PLAN COMMISSION AMENDED AGENDA

August 8, 2024 – 6:00 pm
Village Hall
235 Hickory Street, Pewaukee, WI 53072

TO: Village of Pewaukee Plan Commission
CC: Jenna Peter - Clerk
FROM: Jeff Muenkel AICP, Planning Consultant
RPT DATE: June 28, 2024
MTG DATE: July 11, 2024
RE: Edward Jones – Business Site Plan & Conditional Use Request

Village of Pewaukee Plan Commission
Engineer's Report for August 8, 2024

C1.3

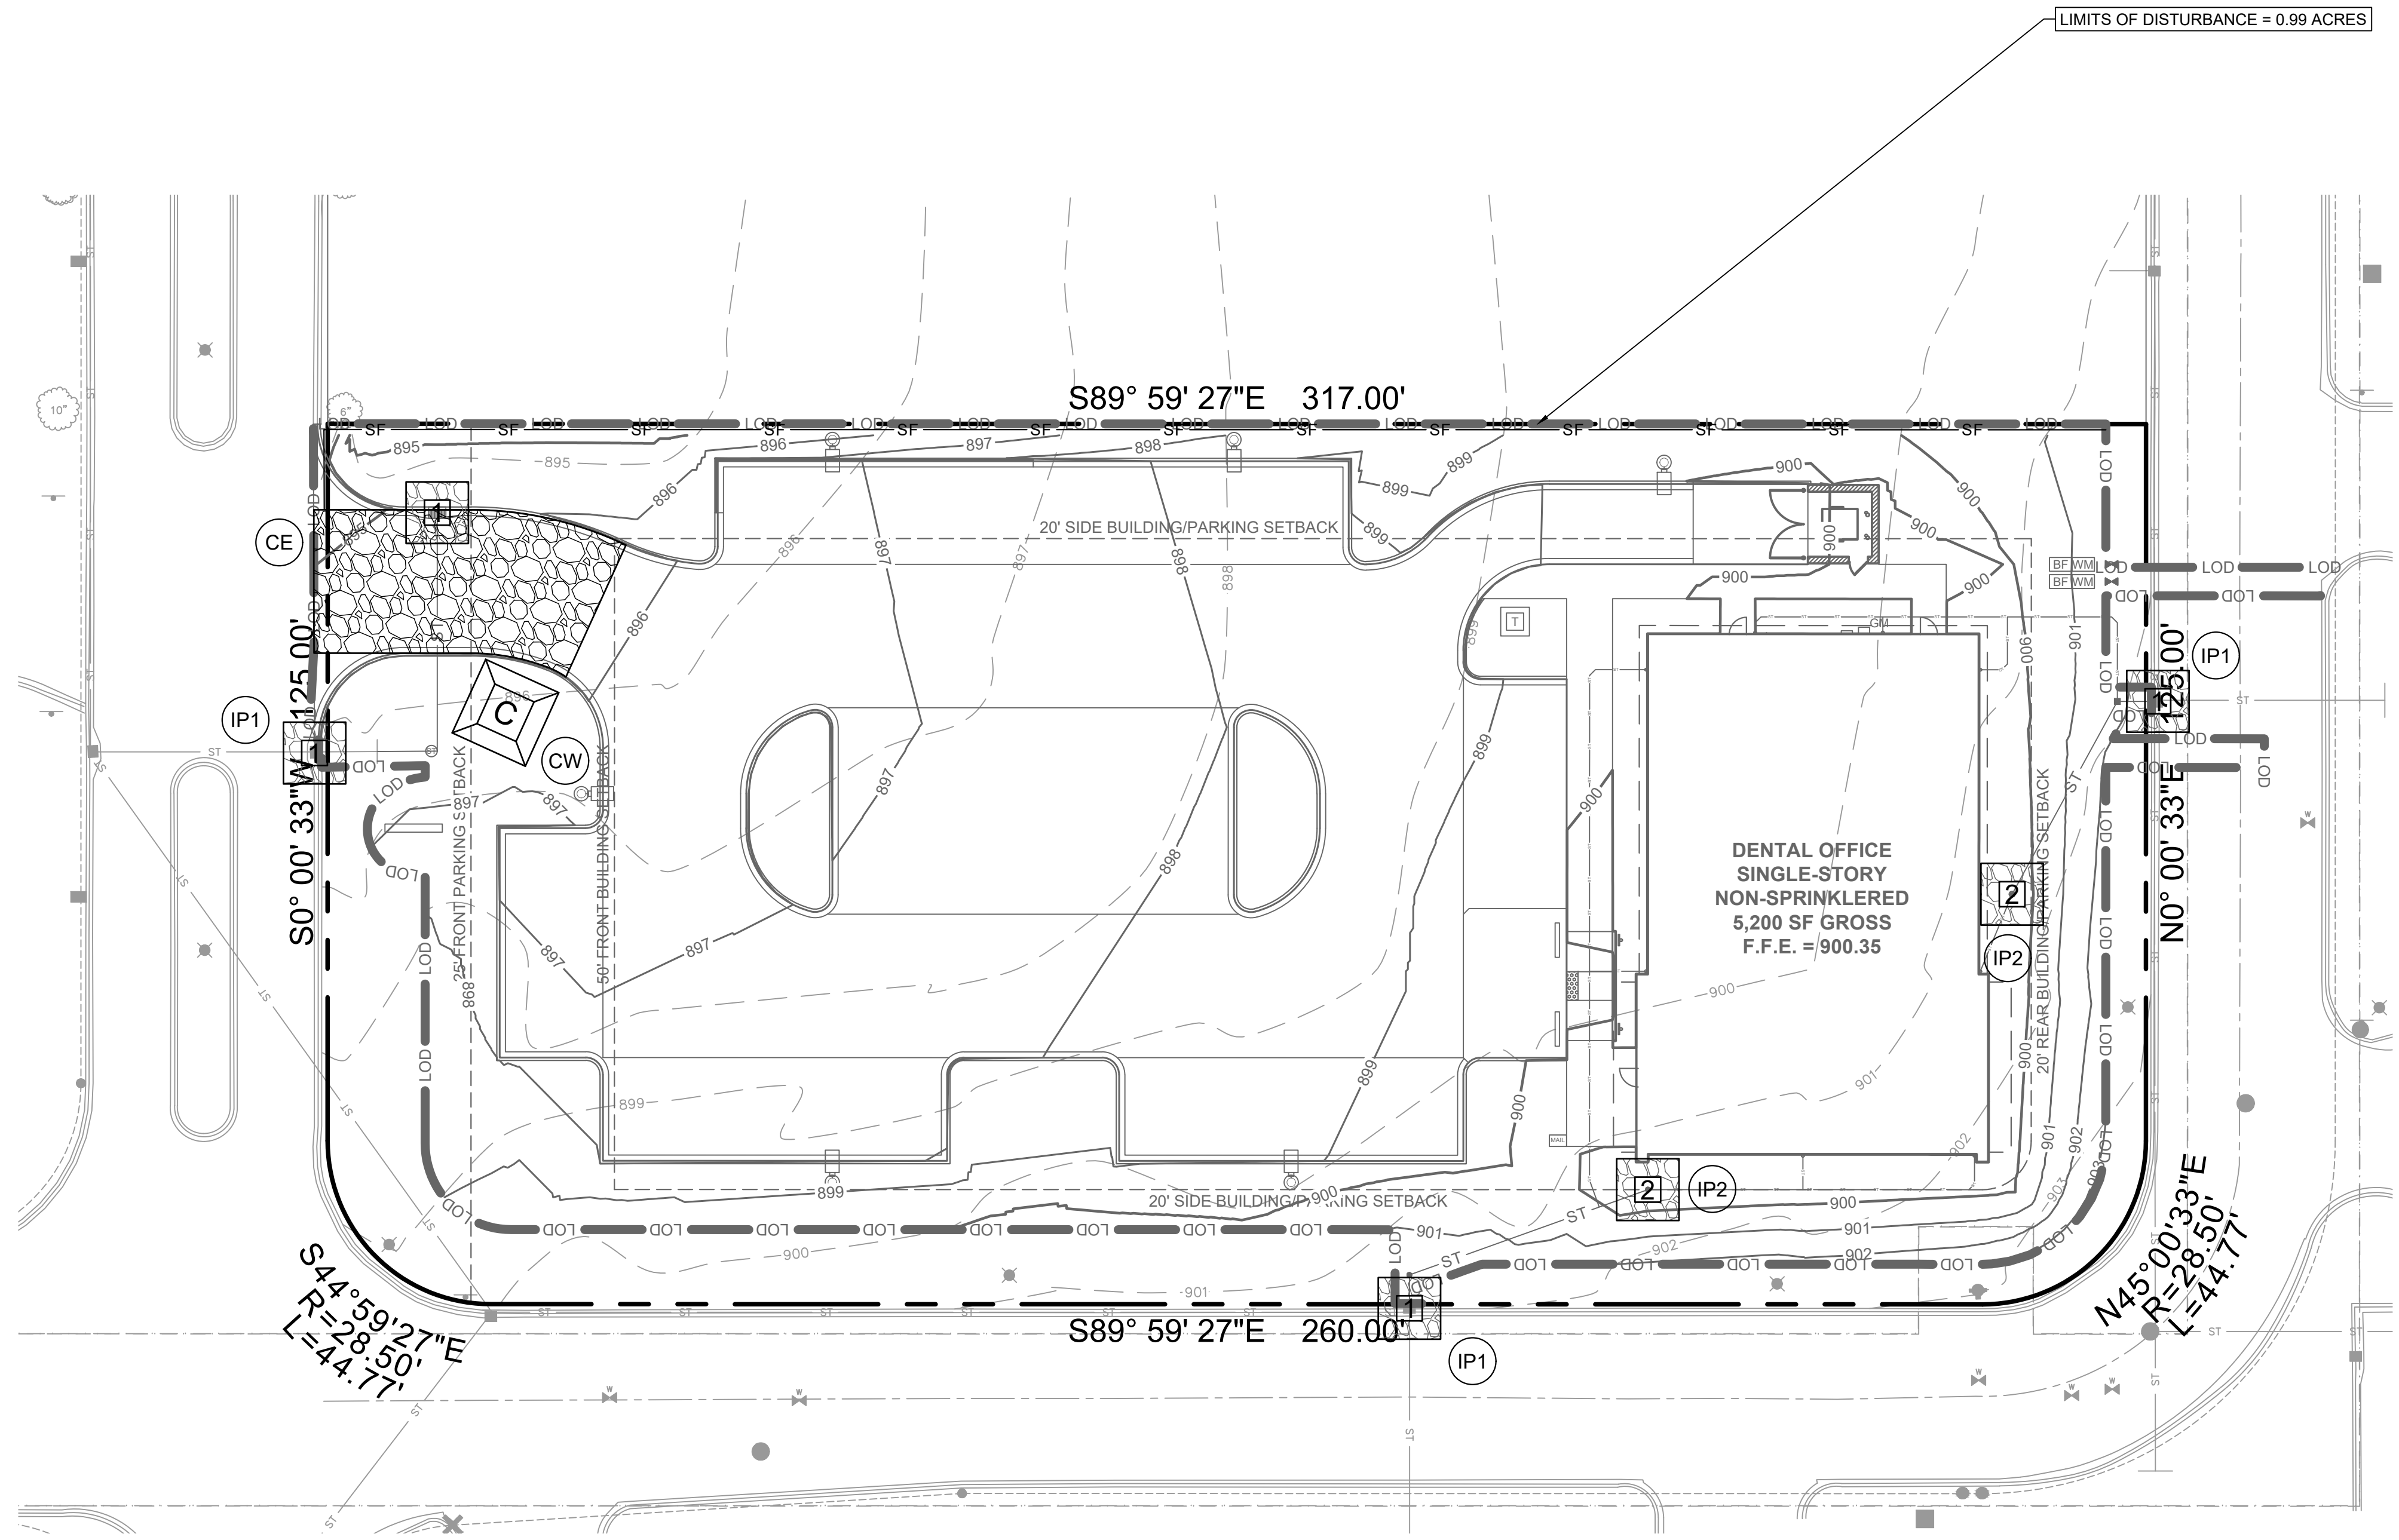
Sheet C1.3

C3.1

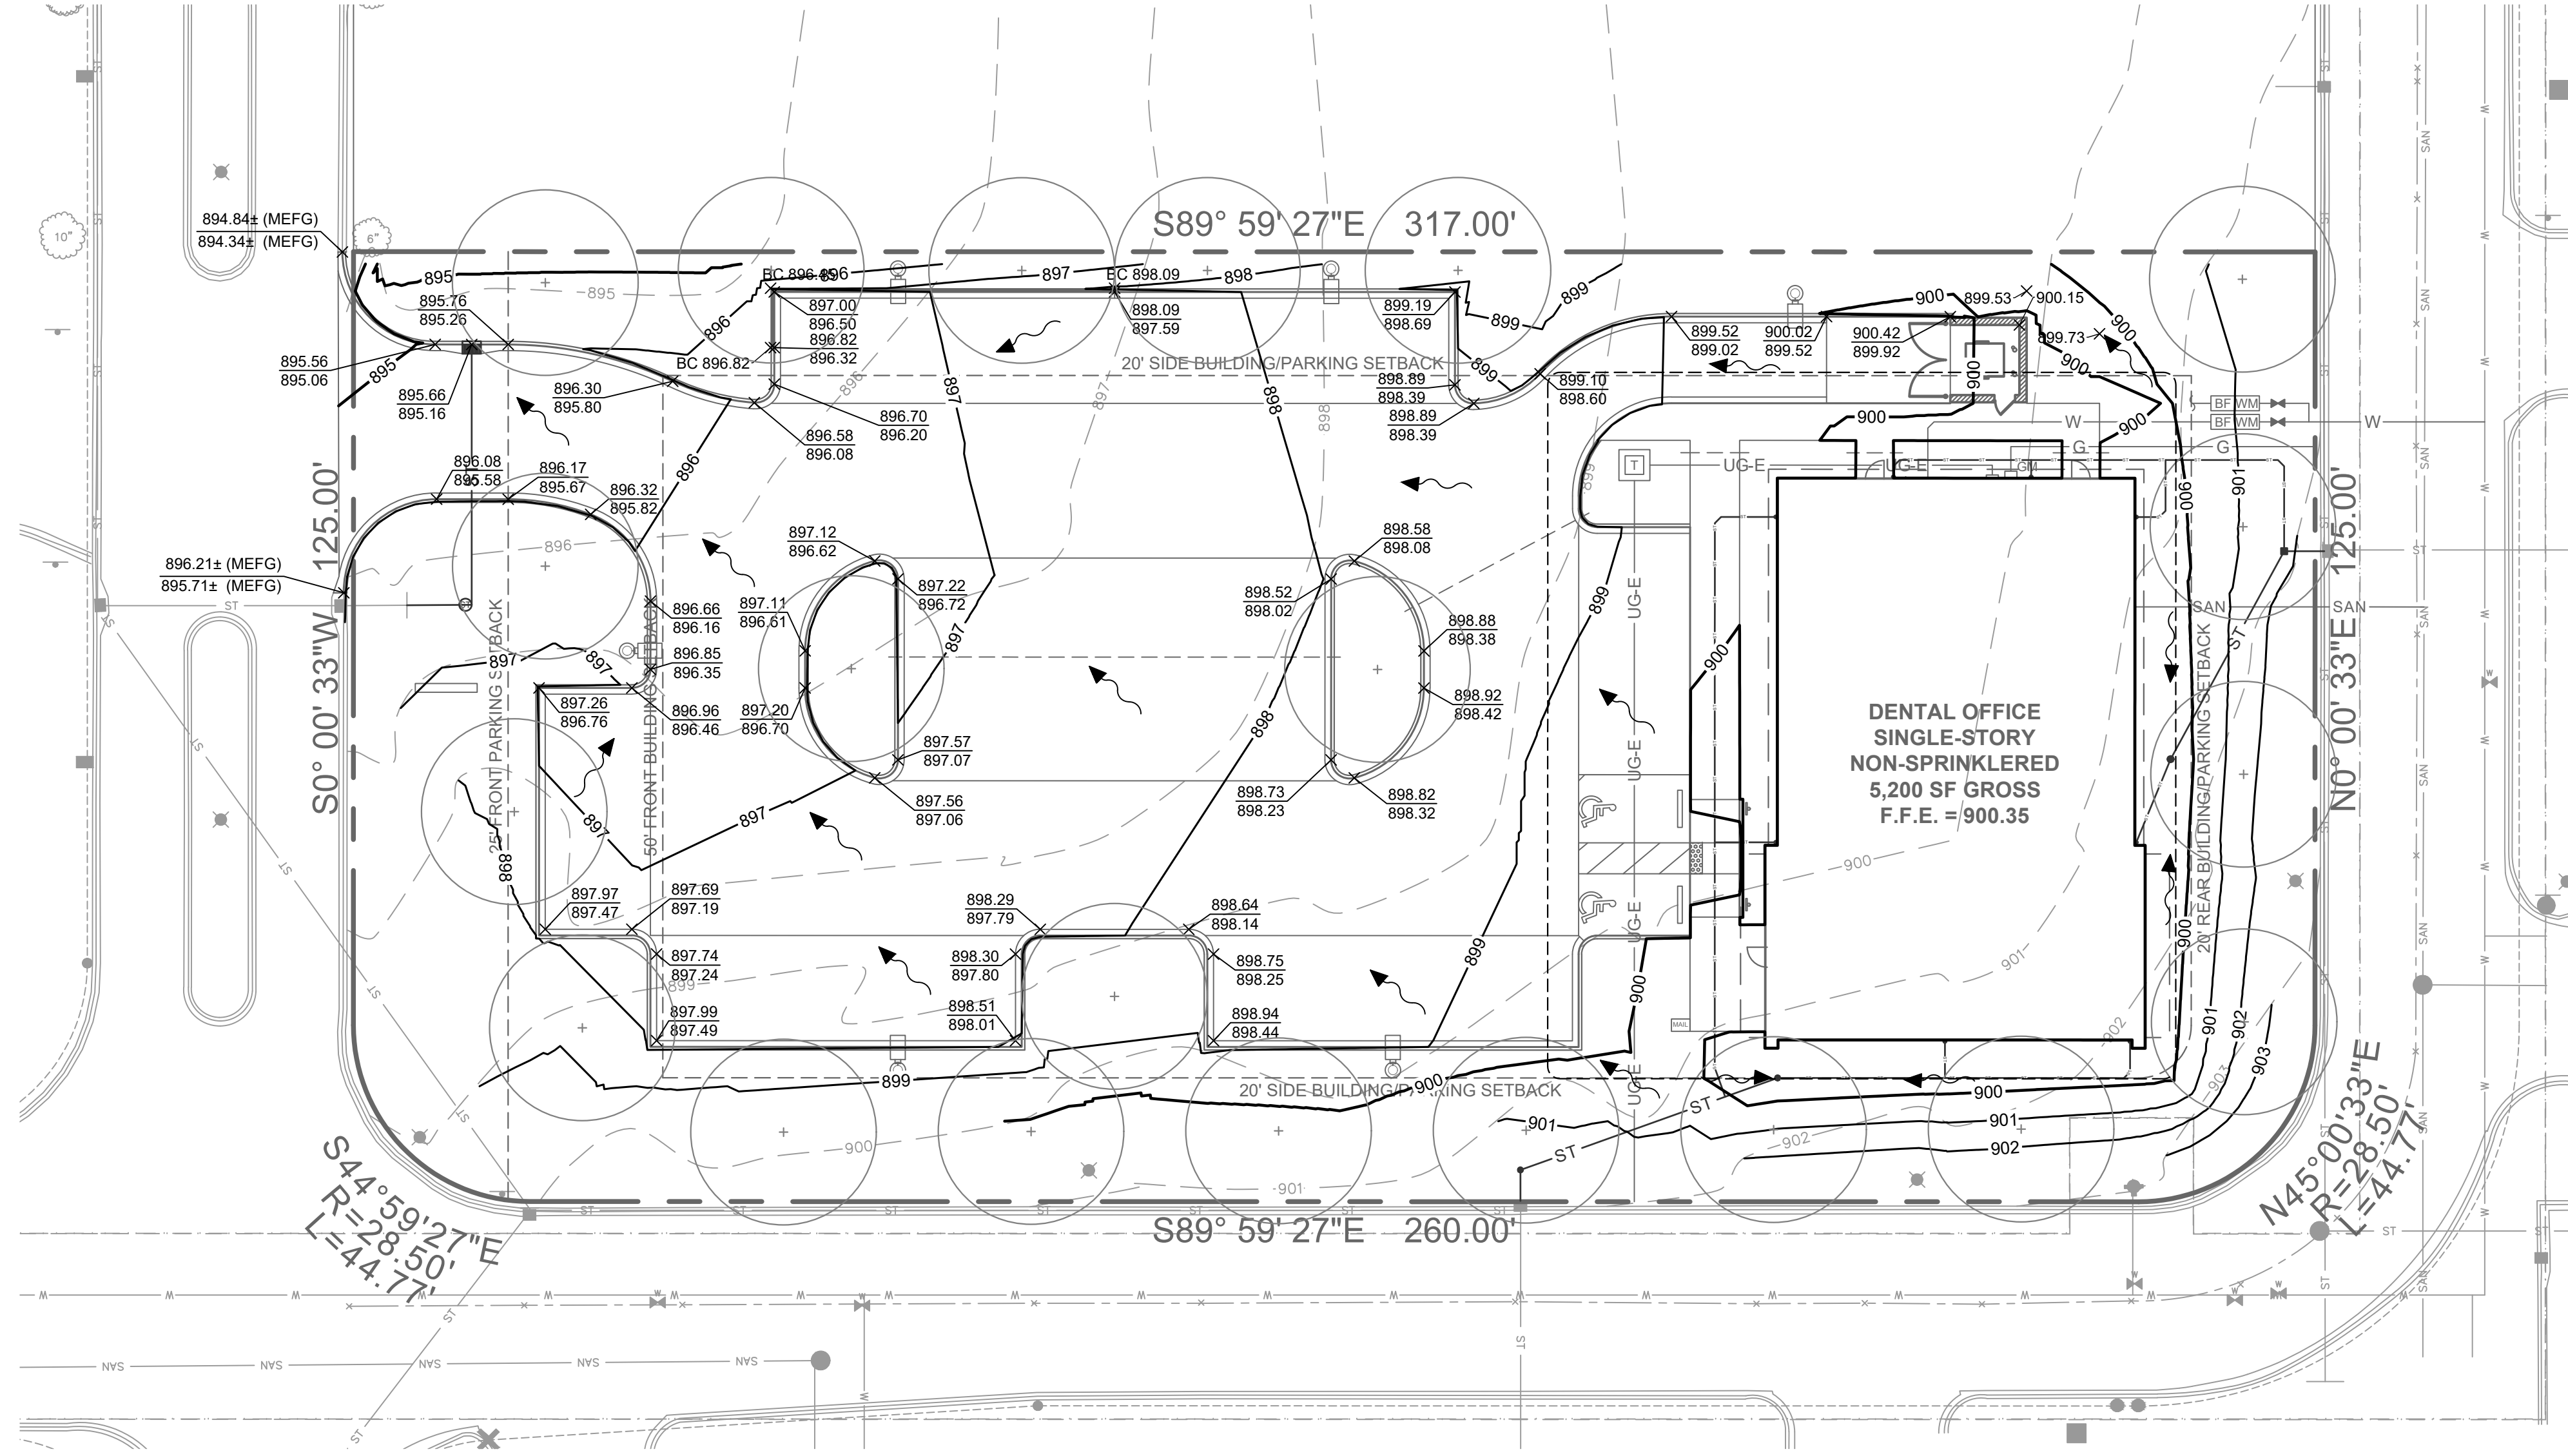
Sheet C3.1
